Request of Class II Permissive Change

FCC ID: APIJBLXTREME3N

This is to request a Class II Permissive Change for FCC ID: APIJBLXTREME3N originally granted on 08/20/2020, due to battery cell added.

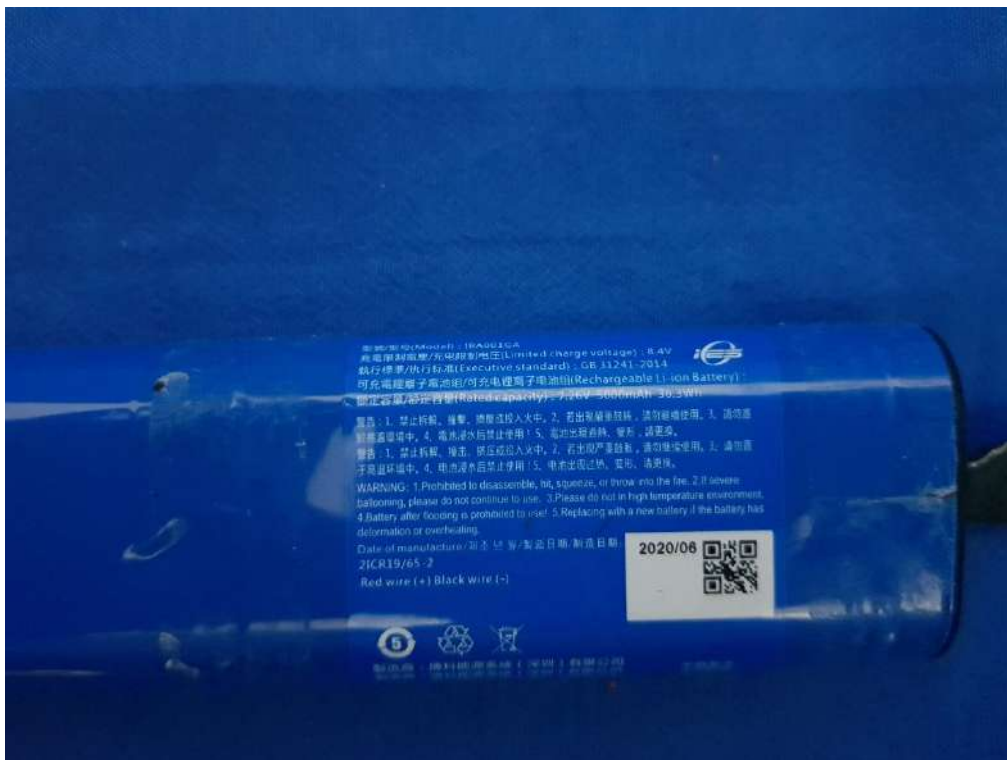
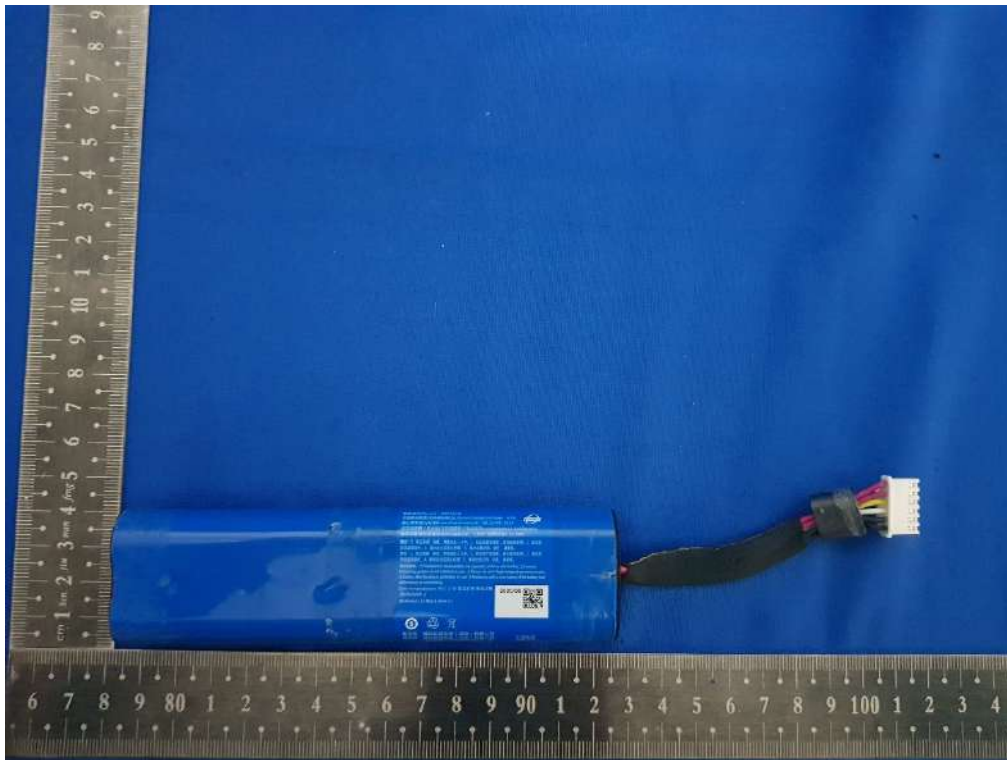
Battery		Manufacture	Model	Description
	Original	ICON ENERGY SYSTEM (SHEN ZHEN) CO., LTD.	IBA001GA	Rated Capacity: 7.26V 5000mAh 36.3Wh; (TI IC BQ28Z610)
	New	ICON ENERGY SYSTEM (SHEN ZHEN) CO., LTD.	IBA001GA	Rated Capacity: 7.26V 5000mAh 36.3Wh; (TI IC BQ27750)

The newly added battery cell will affect the performance of AC power-line conducted emissions and radiated emission (below 1 GHz), and C2PC applied for this.

Original:
Battery:

New:

New Battery IC: TI IC BQ27750
